Appendix 3: BRIDGE SUMMARY- TE MOANA

Site Specific Management Plan 008 -[Sectors 480-510]

MacKays to Peka Peka Expressway

17 APRIL 2015 - REV C - FOR INFO

AEE Consented to DET Proposed Graphic Comparison

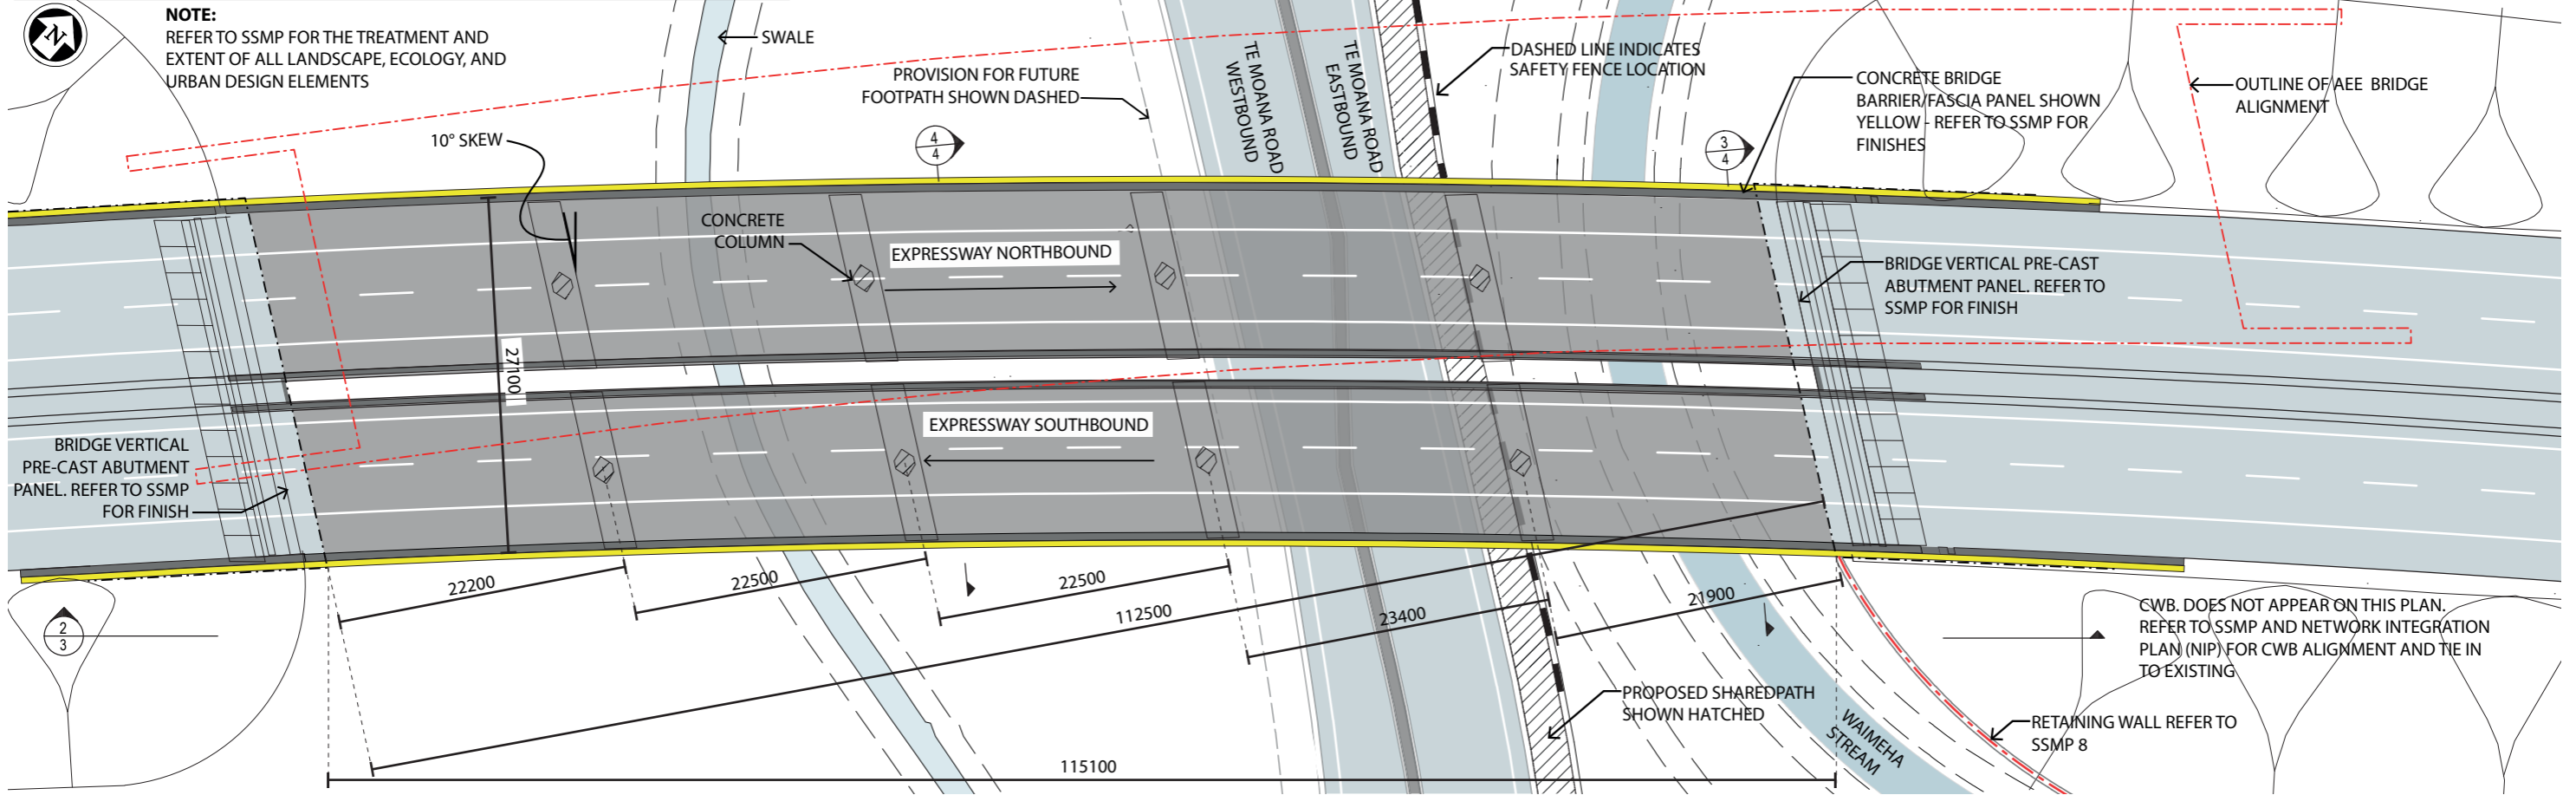
1. Split bridge (1m gap)
2. Remove end span at northern end
3. Column shape and location changed, abutment details refined

4. Reduced number of spans from six to five
5. Expressway alignment changed
6. Change to traffic signals

1. Allows light penetration and better seismically
2. Reduced need for multiple stream diversions, less ecological impact
3. Reduced number of columns (20 to 8) and more open beneath

4. Reduced spans reduces cost. Avoids extra stream diversion.
5. Improved sight distance and safety for expressway drivers
6. KCDC request to allow easier movement for sight pedestrians and cyclists

2. PROPOSED ELEVATION - TE MOANA ROAD CROSSING EAST ELEVATION - 1:500@A3

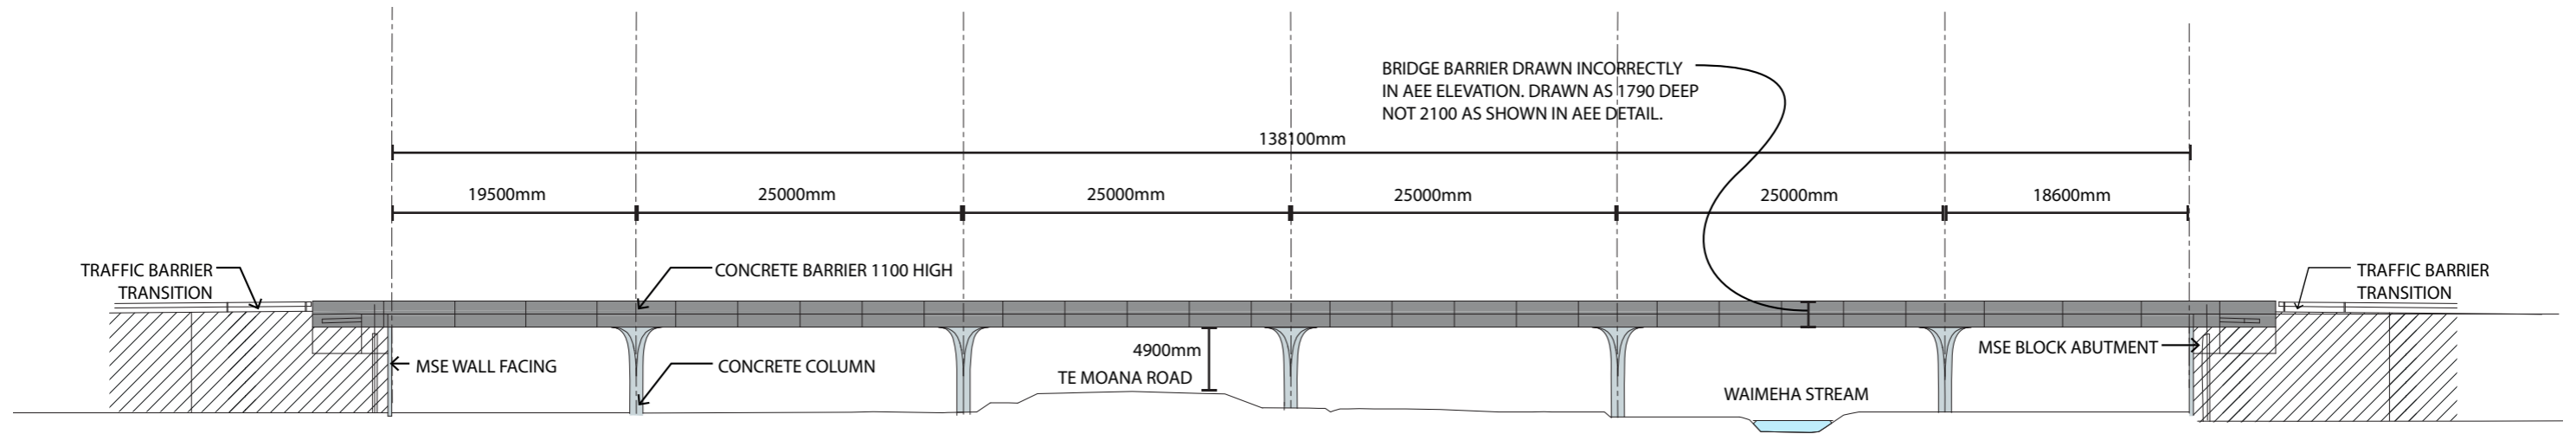
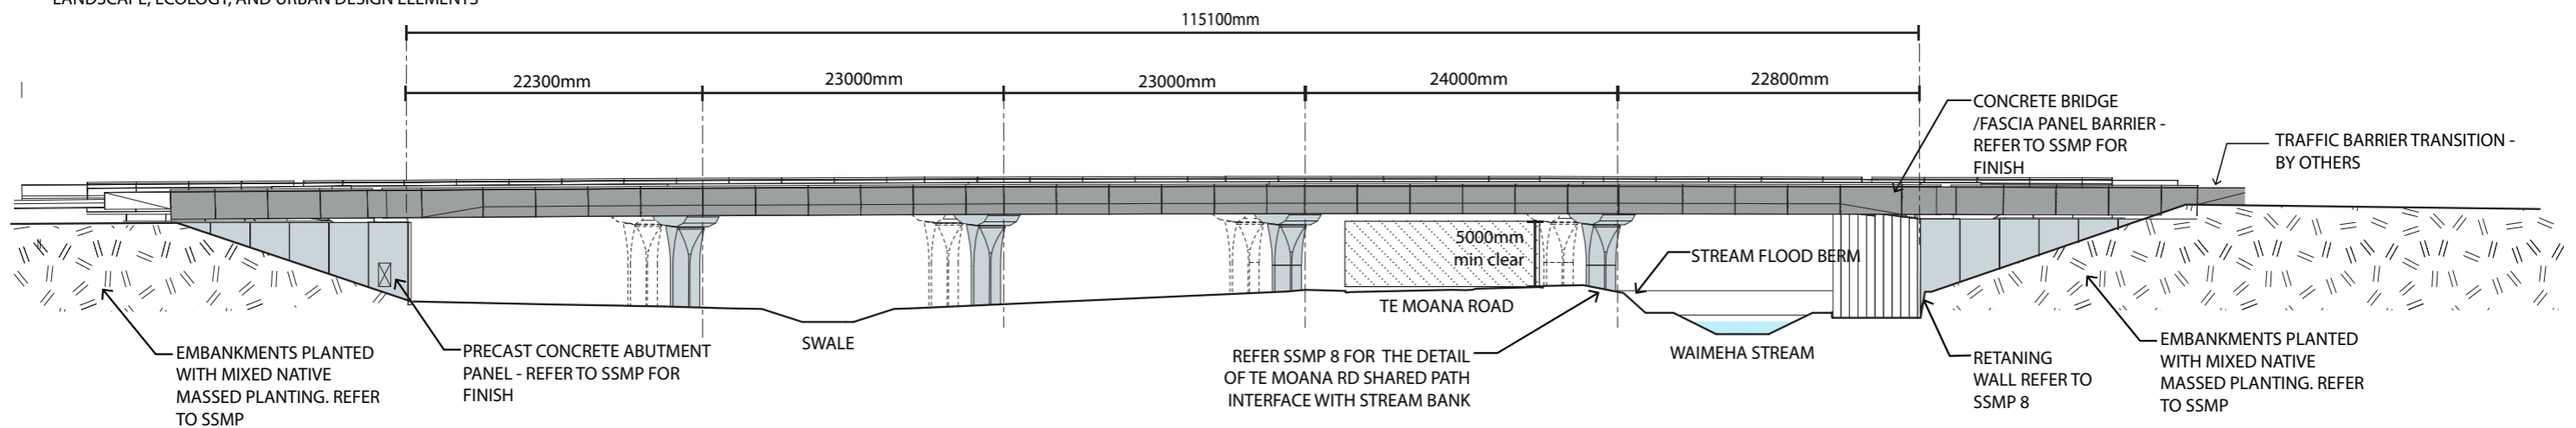
1. Column locations adjusted
2. Column profile developed
3. Reduced overall length of bridge

1. More consistent span lengths, uniformity of structure
2. Increased structural core based on geotech investigations carried out post AEE, while still providing the sculptural outer.
3. Less stream diversions, removal of northern end span

3. PROPOSED SECTIONAL ELEVATION - TE MOANA BRIDGE PIERS (LOOKING NORTH) - 1:200@A3

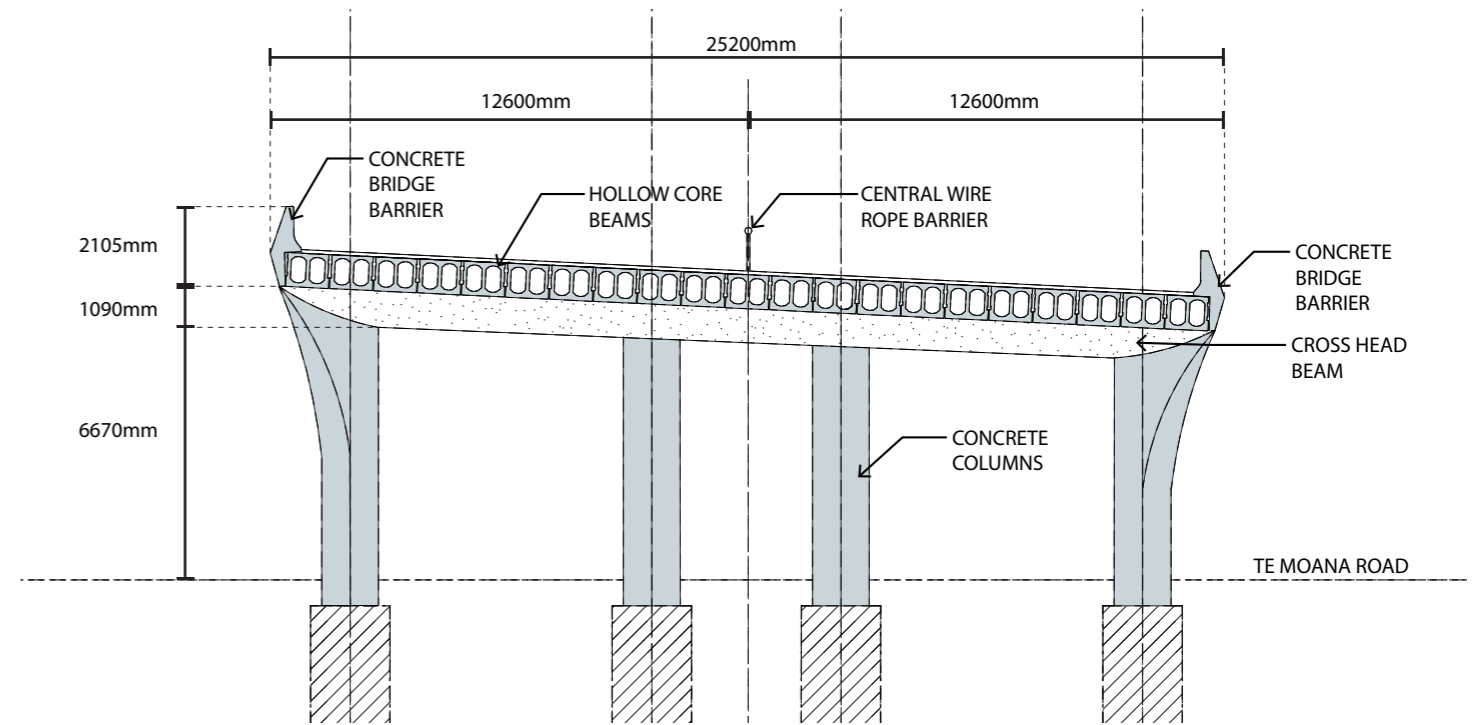
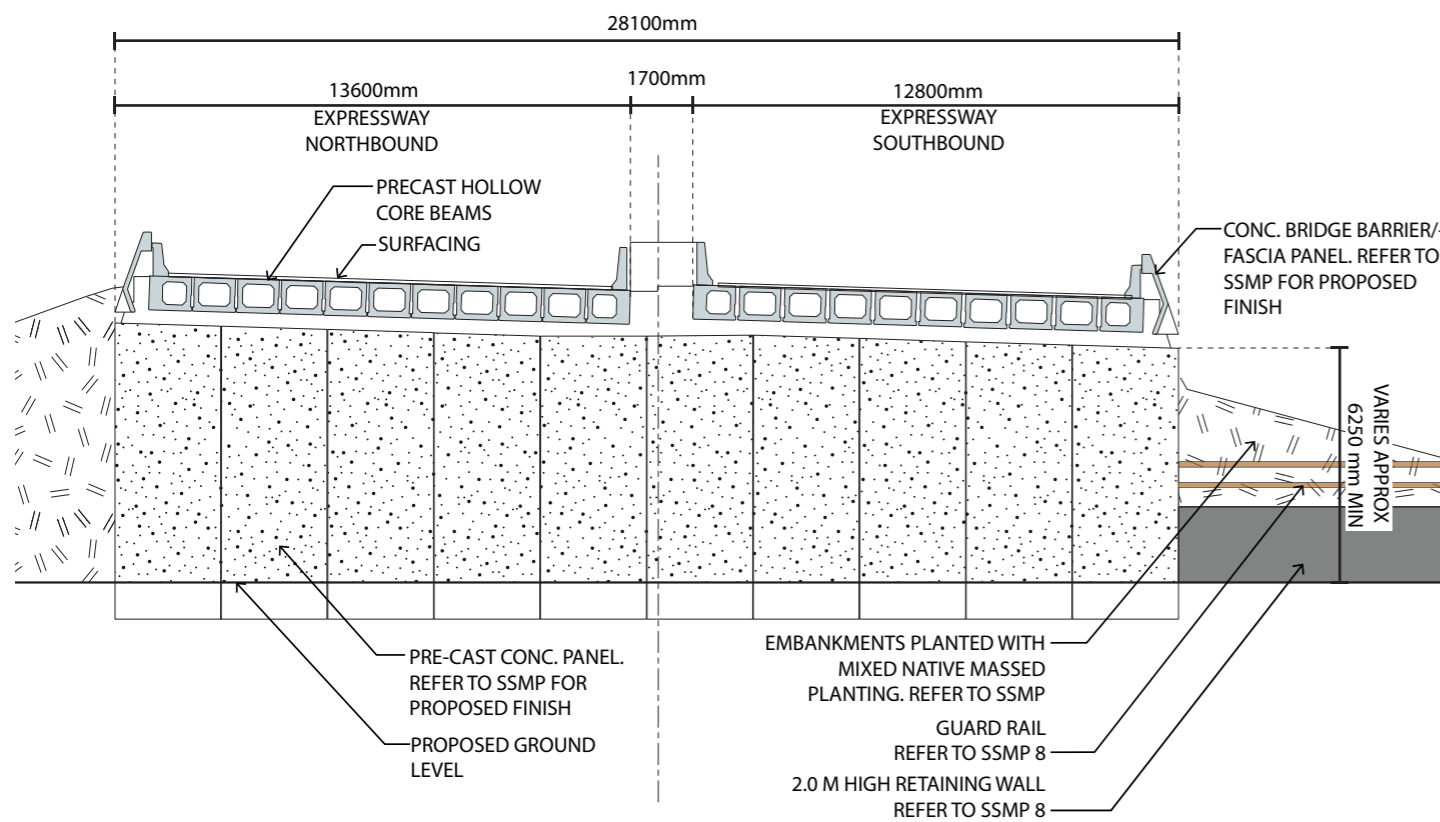
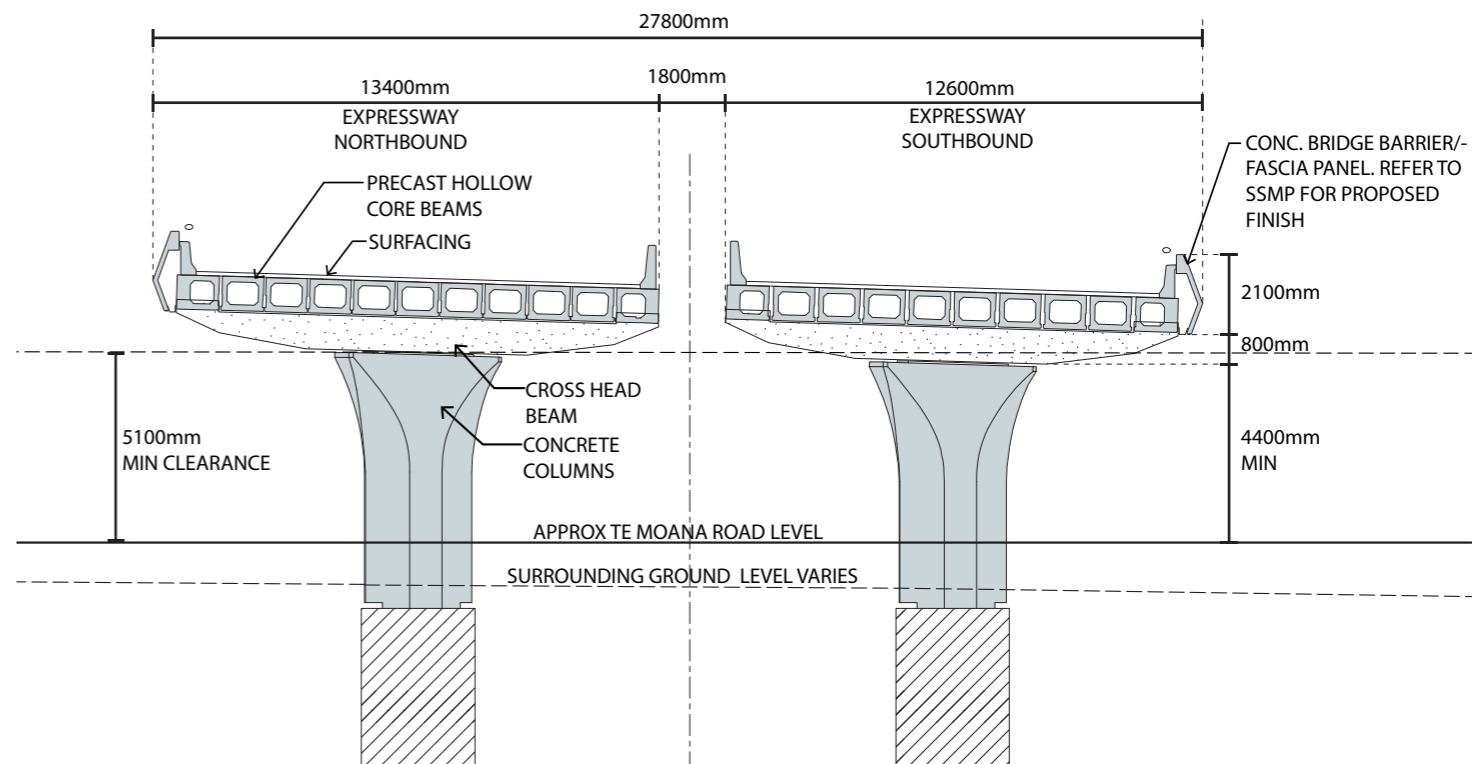
1. Reduced number of columns; 4 columns to 1 column each cross head
2. More detail provided for abutment treatment
3. Split bridge
4. Cross head form changed

5. Column profile developed
6. Simply supported structure

1. Improved visual permeability when considering bridge skew. Total column width when combined is reduced
2. Lack of resolution in AEE Abutment. Design developed
3. Breaks up overhead structure, reduced beam numbers
4. Simply supported structure requires platform to seat beams

5. Increased structural core based on geotech investigations carried out post AEE, while still providing the sculptural outer.
6. Constructability issues because of seismic requirements. Integral connections difficult to build without increasing structural element sizes further.
